**RE: Alameda Development
6100 Alameda NE
Conceptual Grading and Drainage Plan
Engineer's Stamp Date: 09/12/18
Hydrology File: C18D086**

Based upon the information provided in your submittal received 09/12/2018, the Conceptual Grading and Drainage Plan **is not** approved for action by the DRB for Site Plan for Building Permit. The following comments need to be addressed for approval of the above referenced project:

A MIXED USE DEVELOPMENT
at alameda and
san pedro ne.
abq, nm

Conceptual
Grading Plan
date:
9-12-18
sheet:

1 | conceptual grading plan
3 | 1"=30'

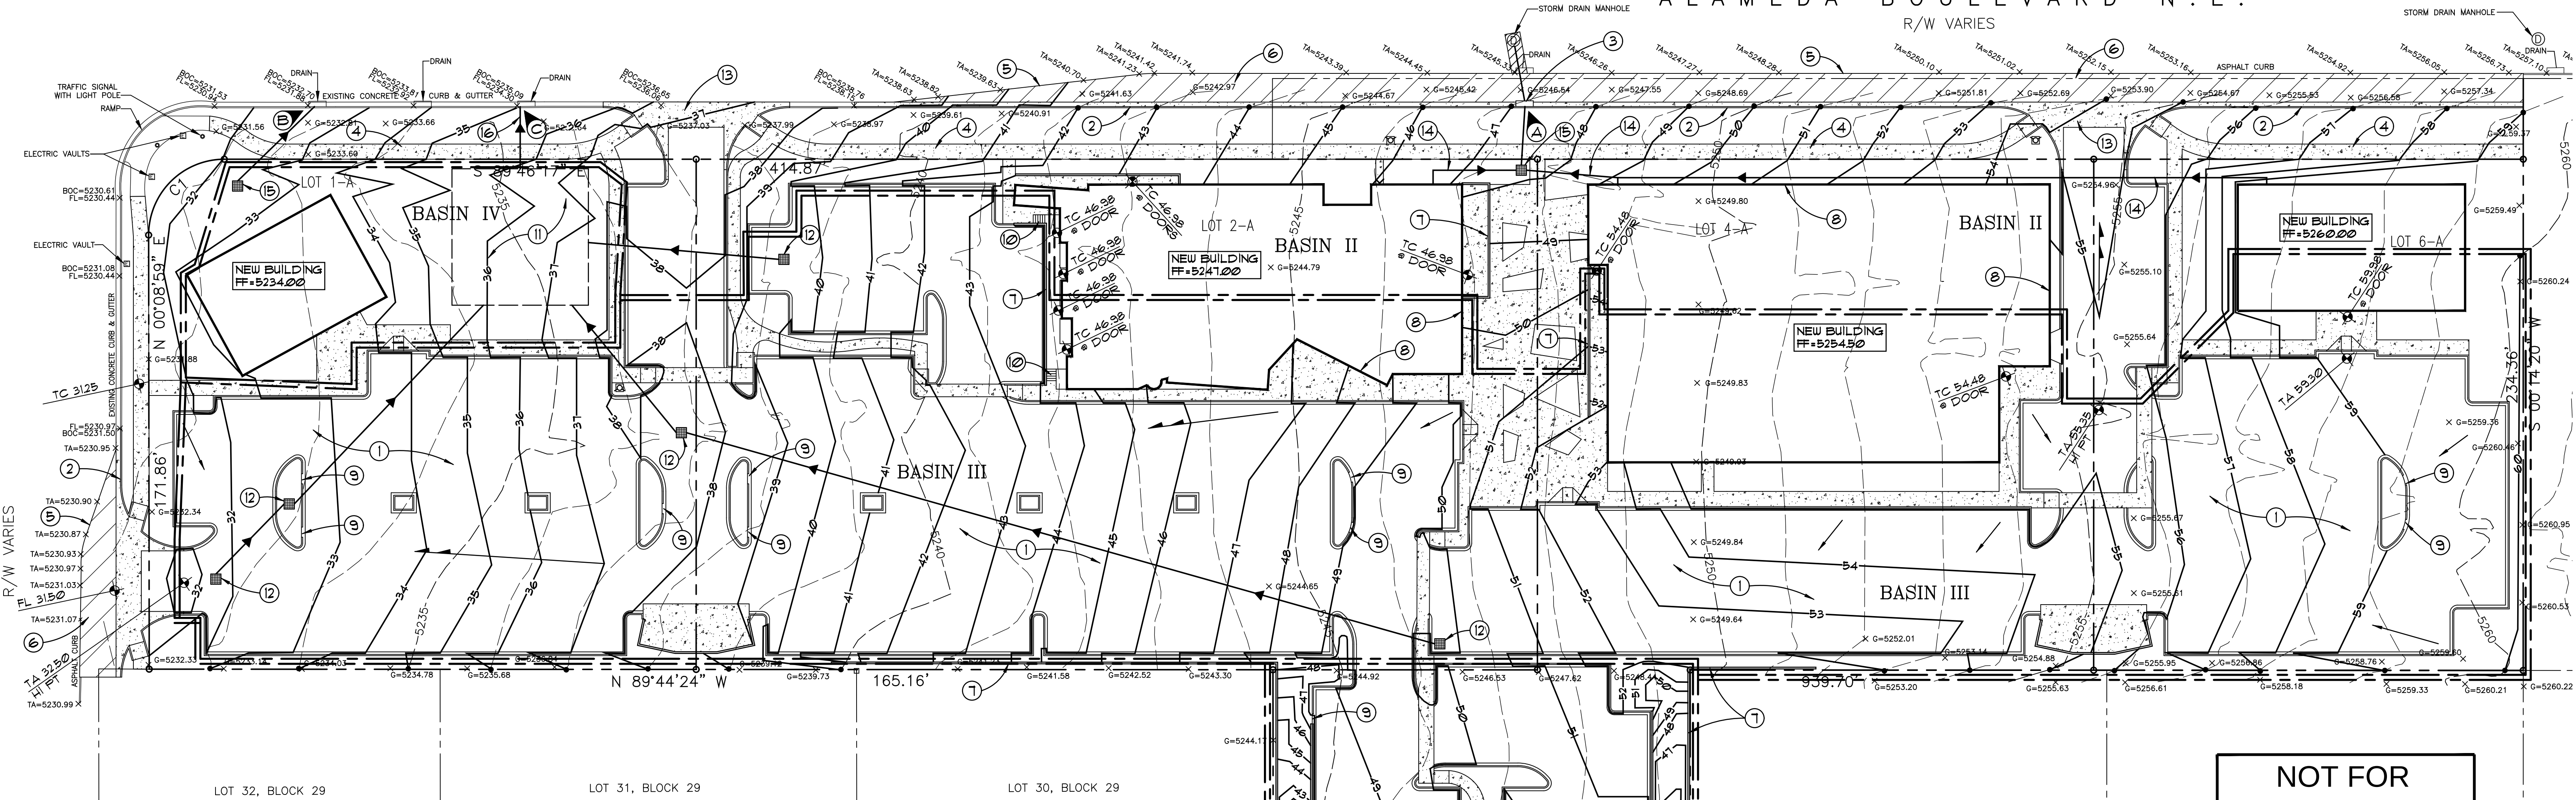
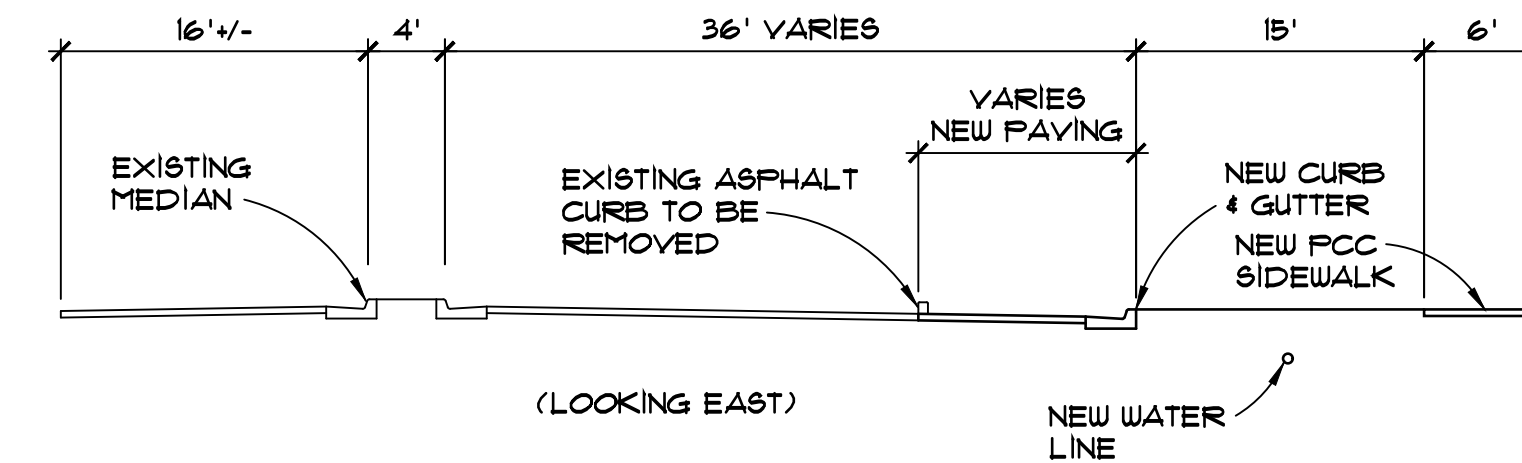
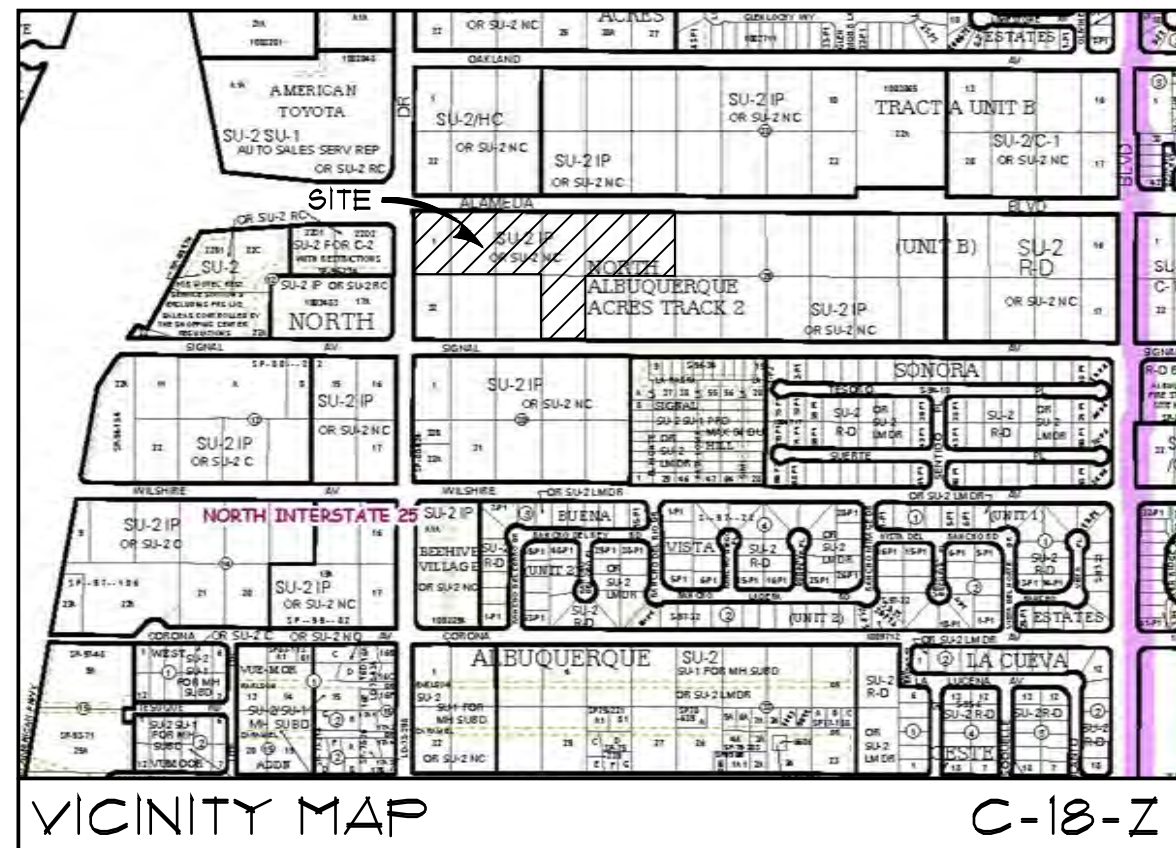
1. Sheet 3. Basin II is missing the northern boundary line along, please add this.
2. Sheet 3. Please reevaluate Basin II's area. It appears that a portion of the building on Lot 2-A and drive entrance should be included in Basin III which discharges into the underground system.
3. Sheet 3. Please add a water block at the entrances to Alameda Blvd and Signal to ensure that drainage does not leave the site.
4. Sheet 3. Please add an inlet within the drive entrances along Alameda to capture the runoff and direct it to Drainage Point "A".
5. Sheet 3. Please add a berm or add a grade line to redirect the runoff to the proposed inlet in Basin IV. The grading as is appears to allow runoff into San Pedro.
6. Sheet 3. Please call out the storm pipe size.
7. Sheet 3. Please show and label the volume provided for the
